LAND USE SERVICES DEPARTMENT
PLANNING COMMISSION STAFF REPORT

HEARING DATE: November 3, 2016 **AGENDA ITEM # 2**

Project Description: General Plan Renewable Energy and Conservation Element

Applicant:	Land Use Services Department
Community:	Countywide
Location:	Countywide
Staff:	Linda Mawby, Senior Planner
Proposal:	General Plan Amendment to incorporate a new Renewable Energy and Conservation Element.

Figure 10. Covered Species Count in the Pinto Lucerne Valley Eastern Slopes

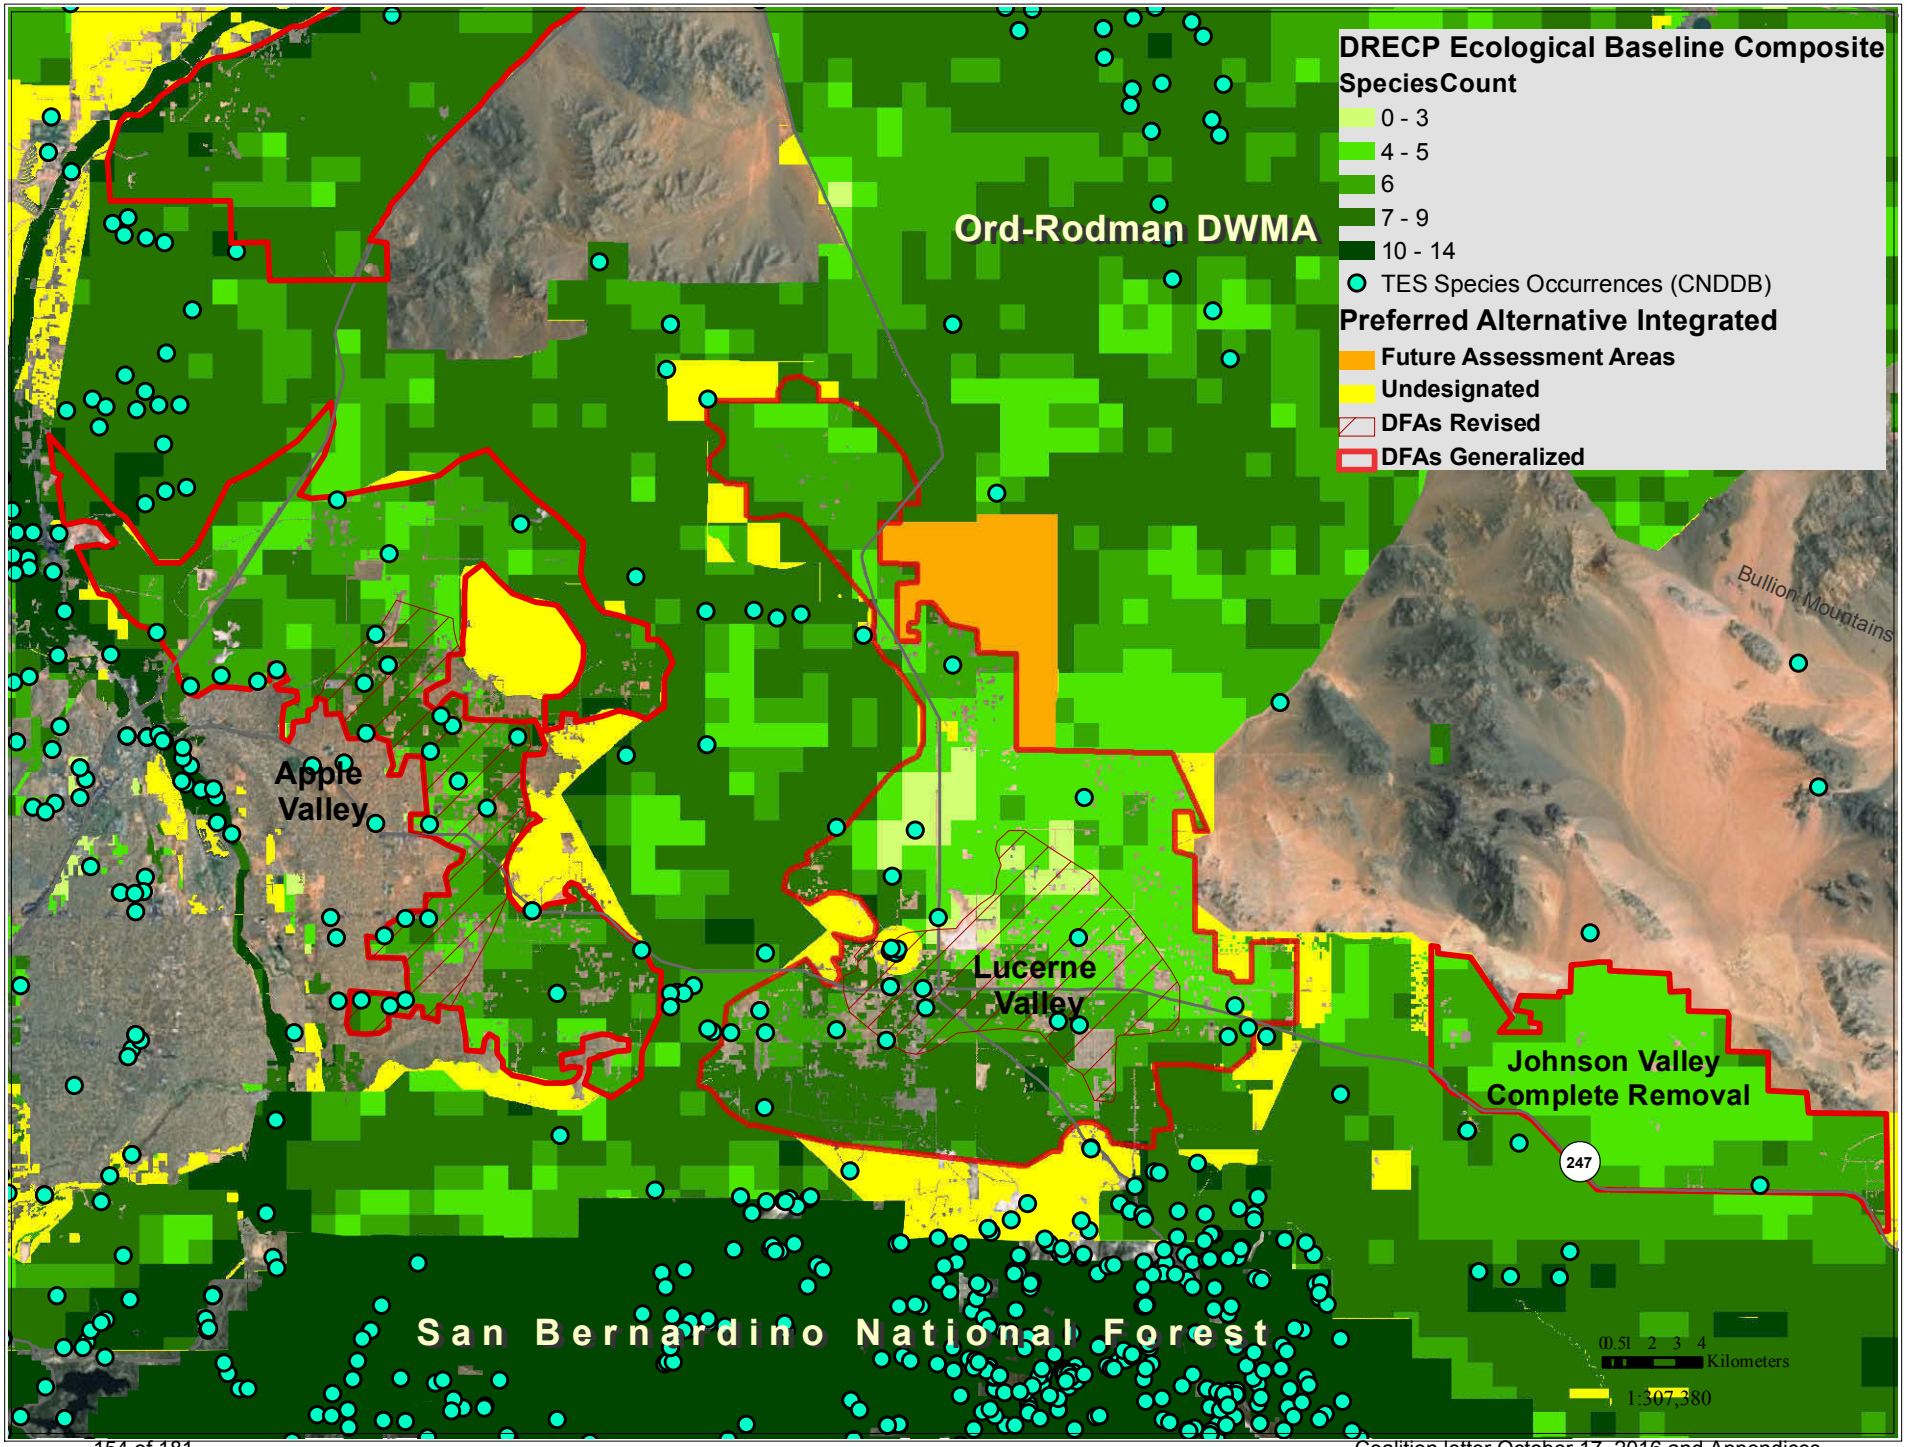
We trust that the above discussion of Reserve Drivers provides sufficient evidence and justification for modification to the Reserve Design in the Pinto Lucerne Valley and East Slopes Ecoregion Subarea. We have also included a composite figure for the other species listed in Table 4 that are also expected to benefit from these modifications to the Apple and Lucerne Valley DFAs and the removal of the Johnson Valley DFA (Figures 10).
